Preliminary Field Check For Drip Systems

COMAL COUNTY

Dear Property Owner & Agent,
Thank you for your submission. We have reviewed the planning materials for the referenced permit application, and unfortunately, they are insufficient. To proceed with processing this permit, we require the following:

118930.pdf Markup Summary 9-16-2025

SYSTEM LAYOUT *
Scale: 1" = 30'

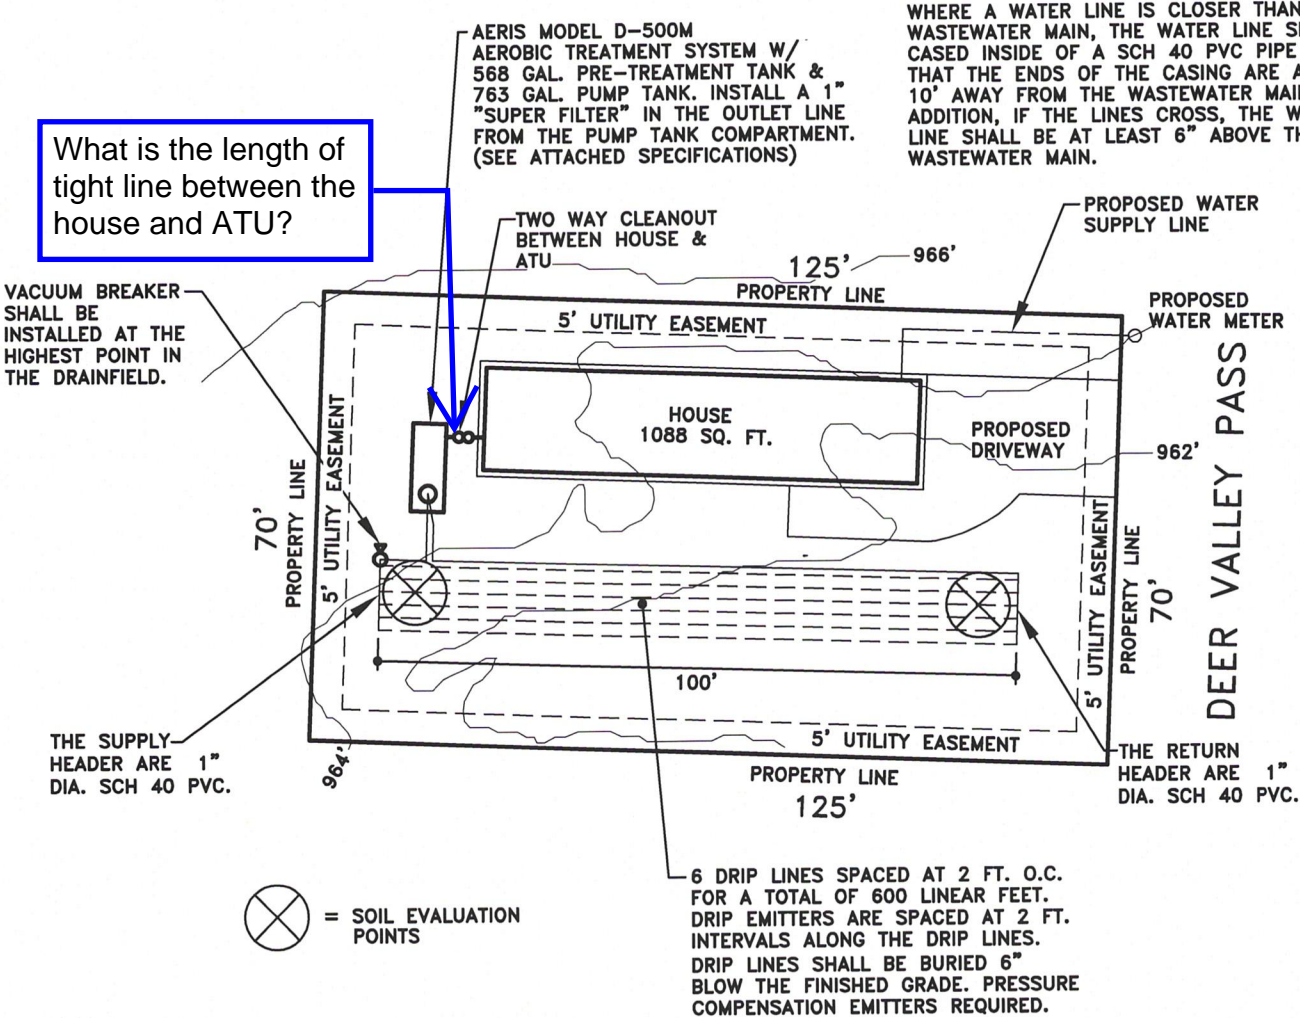
Subject: Line
Page Label: 10
Checkmark: Unchecked
Author: Brandon Mark Olvera
Date: 9/16/2025 1:56:59 PM
Response:

The site plan shows 600 linear ft.

What is the length of tight line between the house and ATU?

What is the length of tight line between the house and ATU?

SIDE SECTION VIEW

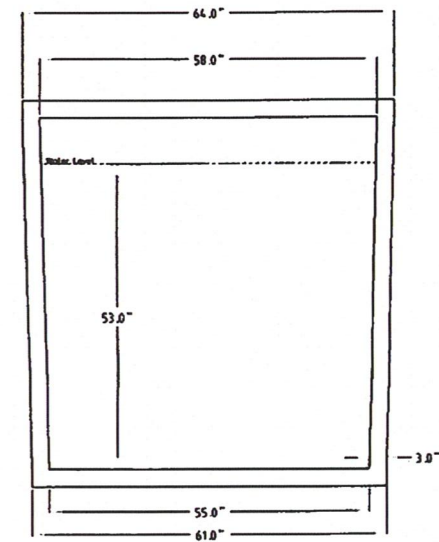
285.34(b):
Provide the pump tank details show the float settings and the 1/3 day flow reserve capacity.
